## Product Change Notification

**1. ECR #:** 193685  
**Notification #:** 522

- UMPT - UMPT ASSEMBLY

- UMPT-XX-XX.X-X-VT-XX-X-XX-X-X

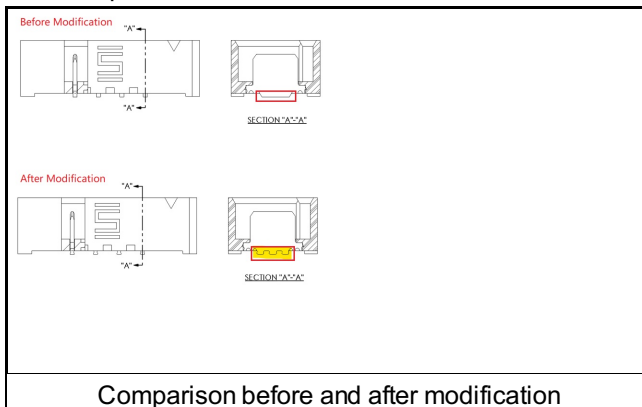
Update model from flat SM tail to grooved SM tails.

Modified contact tails by adding contour to increase solderable surface area and improve solder joint integrity. Revised contact tails passed standard qualification and interconnect processing tests.

- Function - Modified contact tails by adding contour to increase solderable surface area and improve solder joint integrity.
